Reference: **TB 0193 (09/2025)**

Technical Bulletin

Installation: CL7000 incorrect wiring information

Fig1.

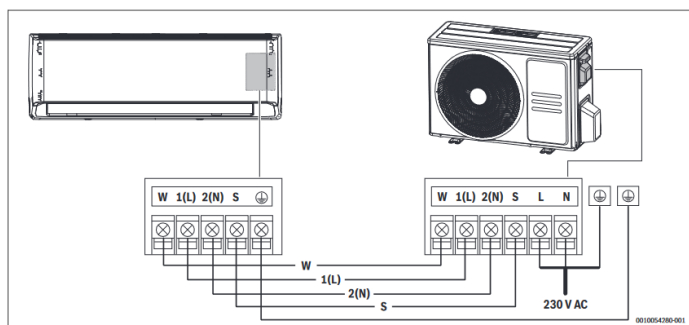
THE INSTALLER COULD CONNECT THE EARTH WIRE TO THE WRONG POSITION, BEING MISLEAD BY THE FIGURE IN THE INSTALLATION MANUAL.

When installing a CL7000 AC unit, there is an incorrect wiring diagram in the installation manual (Fig1).

Fig2.

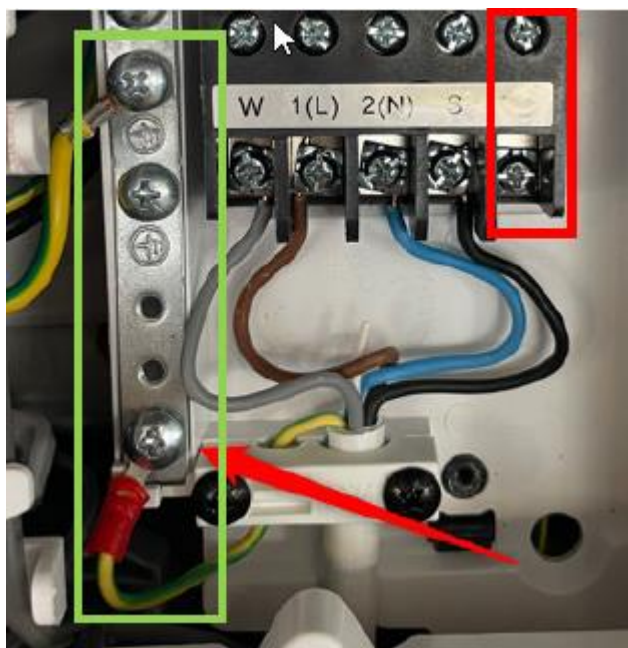
Please see below in Fig2 the correct terminal for the earth wire connection.

The indoor unit power supply cable must be connected according to the wiring diagram which is available on the backside of the front panel.

The next manual release will be updated with this information.

Fig4.

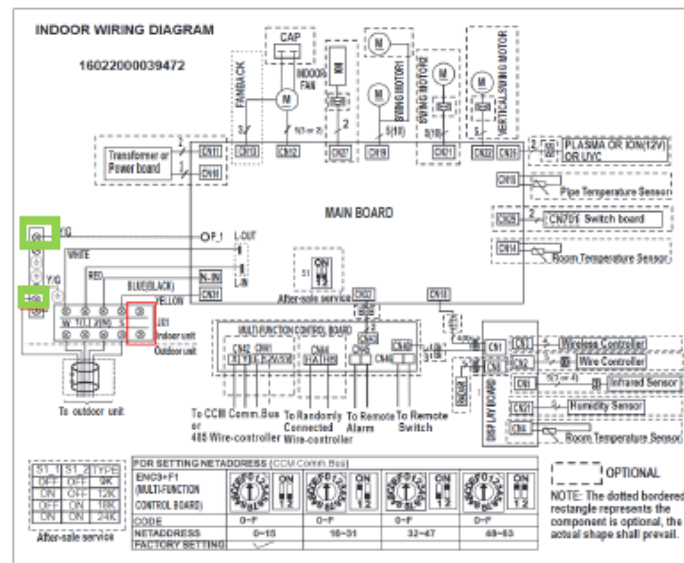
The correct method is shown on the inside of the case on the indoor unit shown in fig3 and fig4.
